Paeriwa Application No APP143988 Additional Information

The following information is in response to items listed in the Waikato Regional Council Notification Decision document dated 3/12/2021 that suggests that further information would be useful in assessing the application APP143988 by Global Contracting Solutions (GCS) for consent to discharge to air.

Figure 1. 99.9%ile SO₂ levels variation with flue gas exit temperature. Background levels and Fonterra discharges are not included

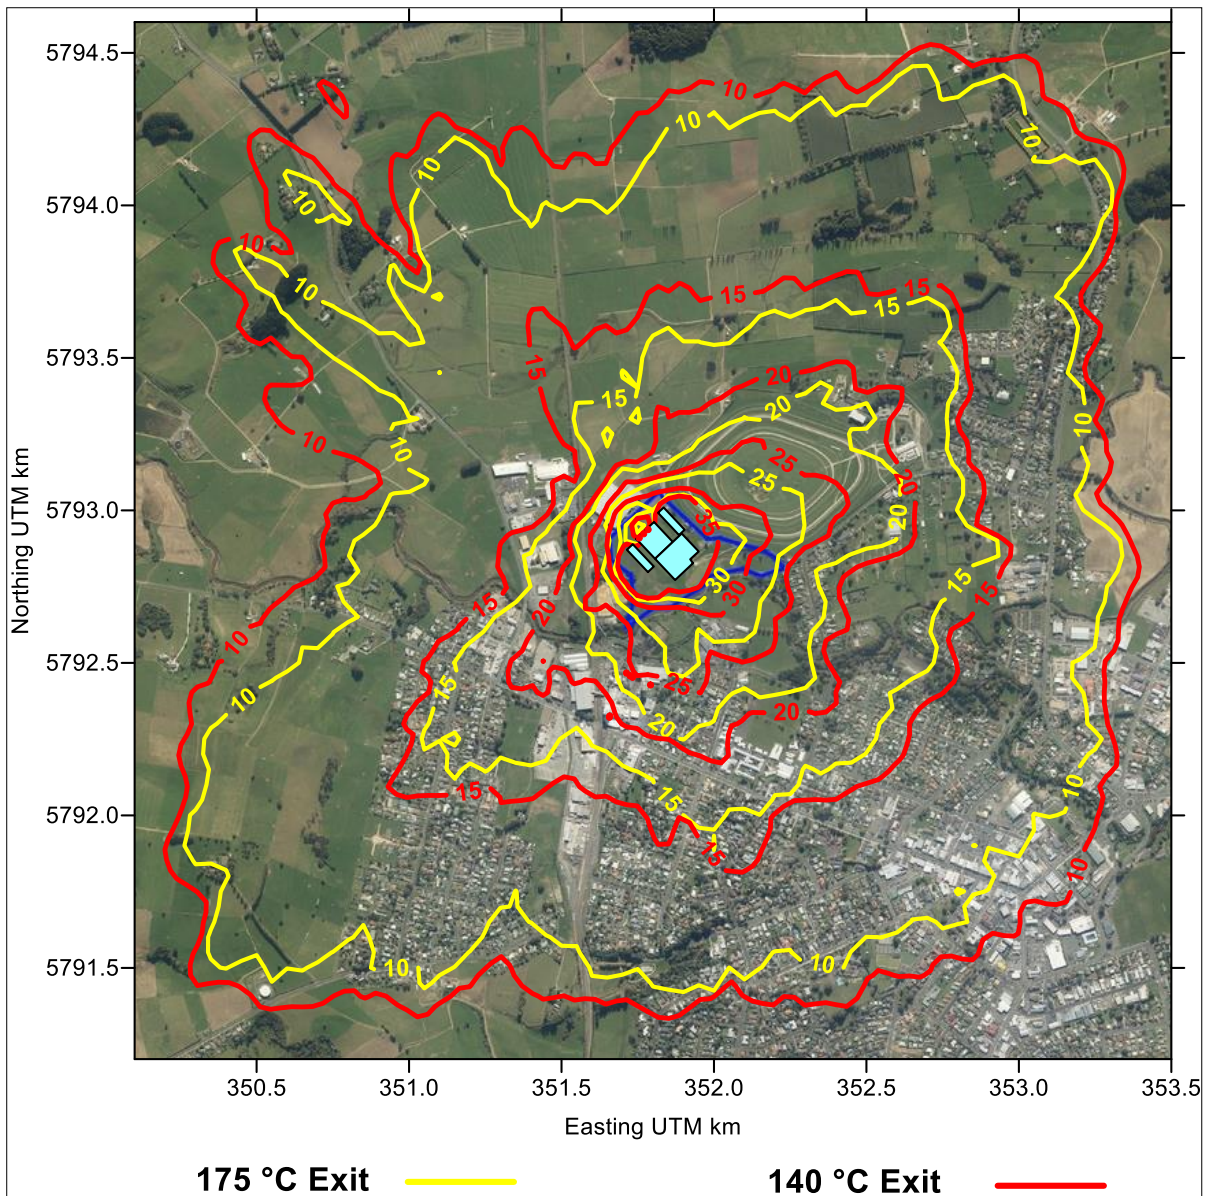
Discharge temp of 175 °C is quite high compared to our experiences in Victoria (where 140 °C is typical) and implies incomplete heat recovery which could end up different in the final design. Modelling should consider sensitivity to discharge temp as this affects the plume buoyancy.

While the flue gas temperatures are never expected to be as low as 140 °C for the Paeriwa plant, as suggested by the council's reviewer, as there is no low grade heat recovery, the effect of a 140 °C flue gas discharge is shown in Figure 1 for SO₂ and only small differences to the predicted 1-hour off-site levels are expected.

However again, we reiterate that the design and operation of the boilers is such that this will not occur unless GCS choose to install low grade heat recovery in the future.

The plots in Figure 1 should be regarded as purely of academic interest only as a lower temperature from heat recovery is not being proposed.

Figure 2. 99.9%ile SO₂ levels variation with stack height for 38m and 50m high stacks. Background levels and Fonterra contributions are not included

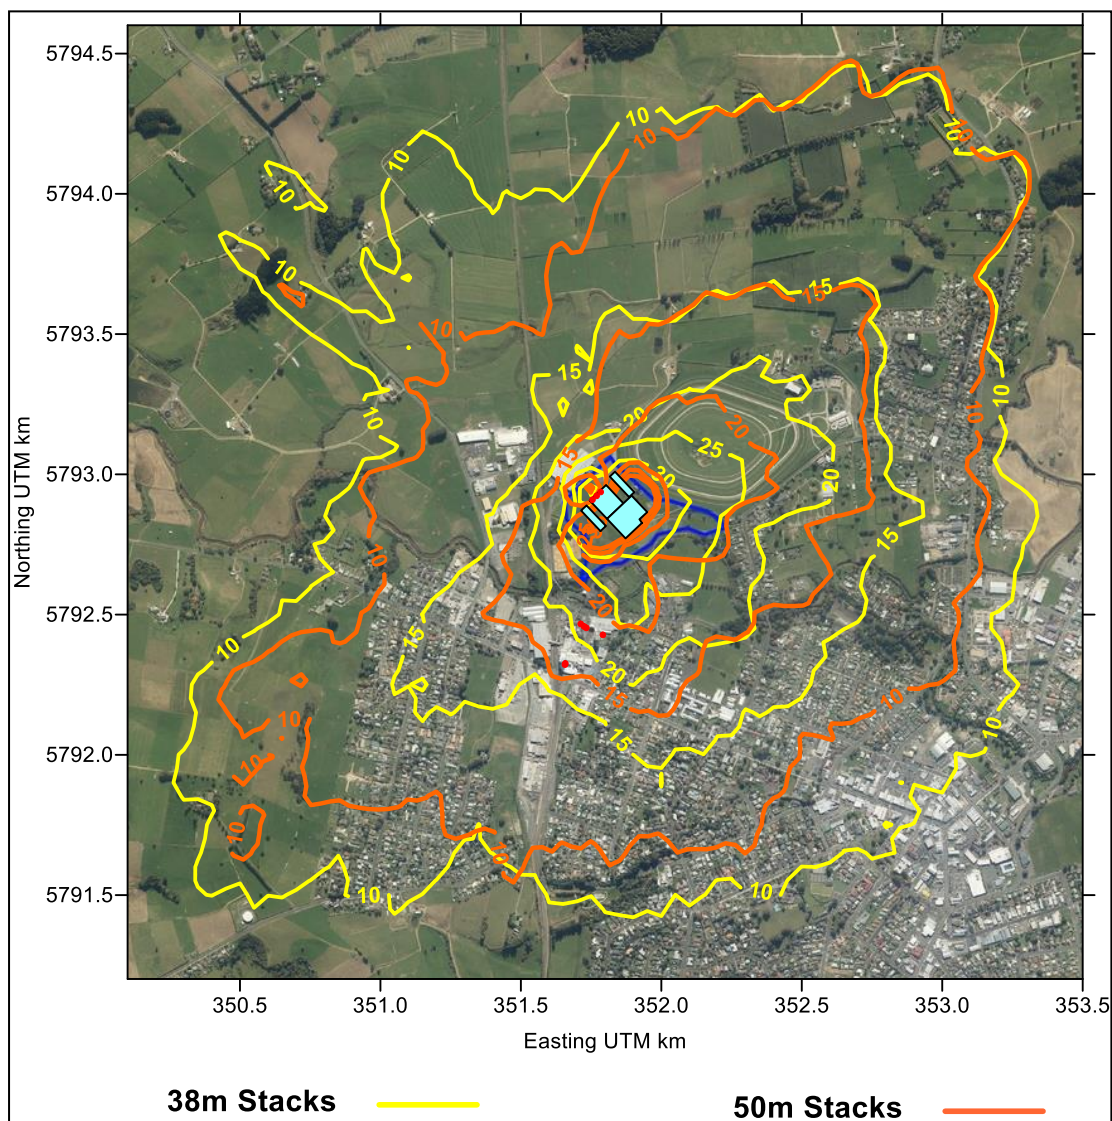
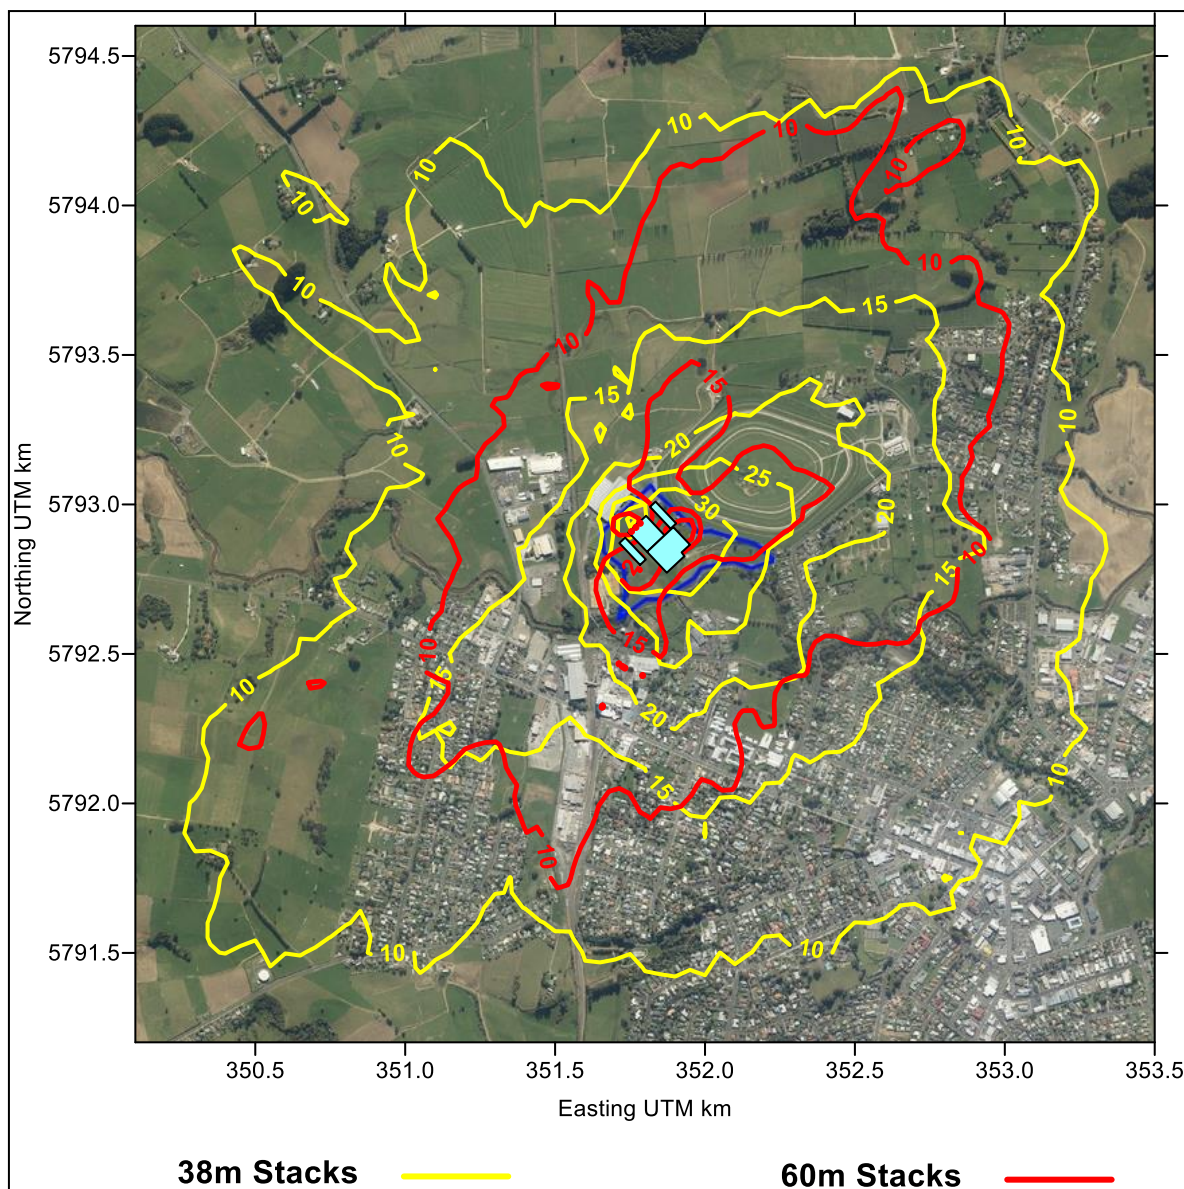
Given all the above, taller stacks may be needed. There is no serious consideration of this and this should be included in a “consideration of alternatives”. There is a small amount of discussion on this in the S92 response, but it needs more detailed assessment.

The 99.9th percentile 1-hour predicted SO₂ levels for 38m, 50m and 60m high stacks are shown in Figures 2 & 3.

There is an incremental reduction in ground level concentrations very close to the plant for the increase stack height going from 38m to 50m stacks, but the differences at greater distances vary from moderate to negligible. The greatest reduction amounts to about 20% for some locations immediately adjacent to the plant boundary for a 50m height compared to the proposed 38m, but other locations that are also on the boundary, there is no significant change e.g. the SW boundary. There is also no change for some locations 600 to 1500m to the SW of the RDF plant and 500 to 1600m to the NW. While not shown, the effects for 55m stacks are similar to those of 50m.

For 60m high stacks there is a reduction in off site effects for some locations close to the RDF plant boundary but minimal change for more distant locations as for the 50m stack option.

Note also that these modest improvements apply only to short term 1-hour impacts that are only relevant to SO₂ and NO₂ which already comply with appropriate NZAAQS's for the 38m stacks and extended stacks of 50 to 60m high are not considered to be warranted.
